Liberty Knitwear (Unit-2) Ltd #11570

10.May.2014

Identified Priority 1 Concerns

1st Priority 3 Concern

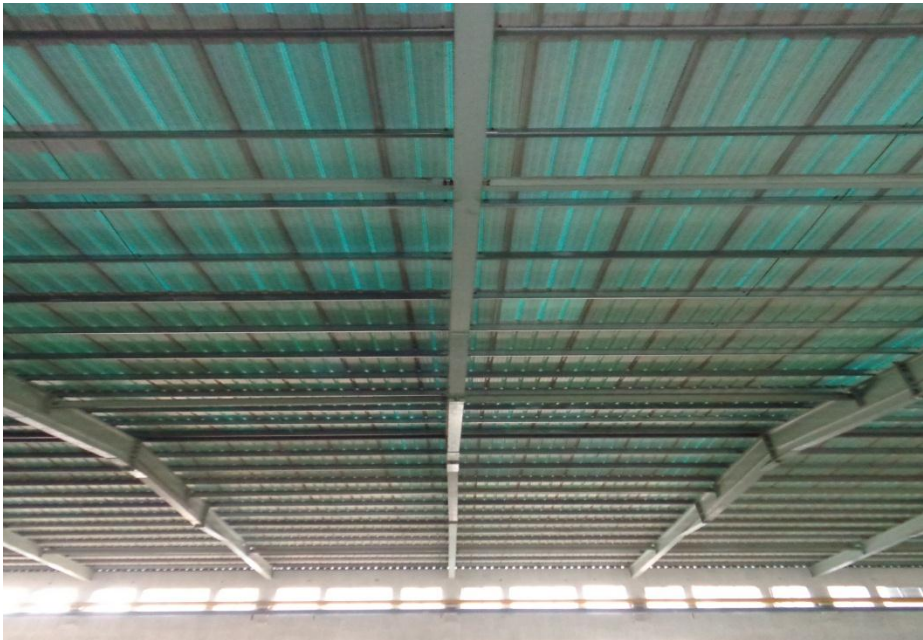
Detailed structural drawings are not available for “pre-engineered” roof structure of dyeing and finishing buildings.

Factory owner does not have detail drawing for steel structure. Detail drawing should be compiled for future reference.

Item No.	Observation	Recommended Action Plan	Recommended Timeline
1	Main building – Design load exceeded, loading to be reduced.	Redistribute material in storage areas to respect design load of 3 kPa (60 psf). Evacuate construction debris from stairs and add supervision to prevent future occurrence.	Immediate – Now
2	Main building – Design load exceeded, loading to be reduced.	Implement better control to prevent overload of floors by construction materials. Implement better supervision of floor loadings in storage areas.	6-weeks
3	Detailed structural drawings are not available for “pre-engineered” roof structure of dyeing and finishing buildings.	Detailed structural drawings to be sent to owner of building	6-months
